RE: **Lot 28 Block 8 Volcano Cliffs Unit 22 SAD 228
6315 Petirrojo Dr. NW
Grading and Drainage Plan
Engineers Stamp Date 5/10/2021 (D10D003E28)
Pad Certification Date 7/12/2021**

Based upon the information provided in your submittal received 7/12/2021, this plan is approved for Building Permit.

Lot 28 Blk 8 Un 22 VC
6315 Petrojo Road NW
GRADING AND DRAINAGE PLAN

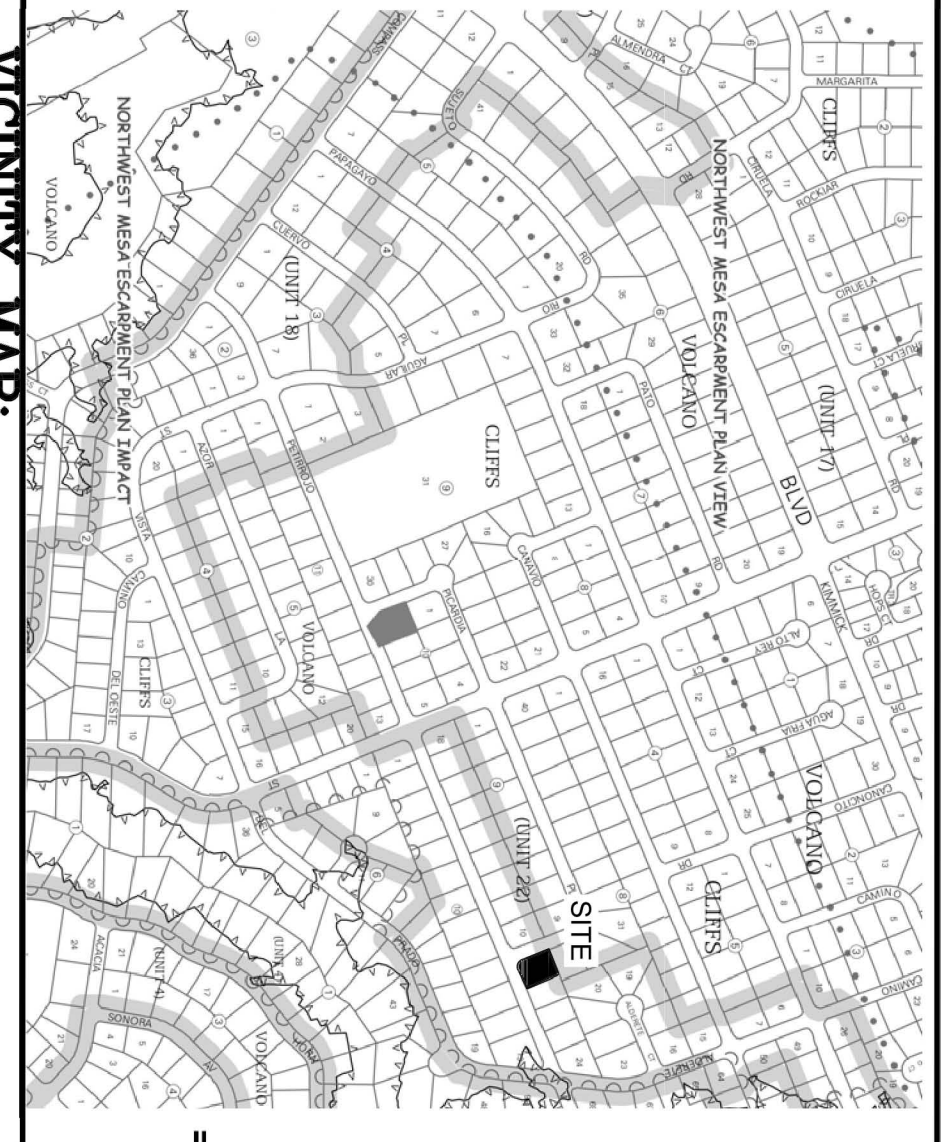
Reiterate to the Owner/Contractor that a separate permit for a garden/retaining wall must be obtained, with the approved G&D plan and Pad Certification. Also, let the owner/contractor know that if a pool is to be added in the future the G&D plan will need to be modified showing the location of the pool and the land treatment differences.

Prior to Certificate of Occupancy release, Engineer Certification per the DPM checklist of this plan will be required.
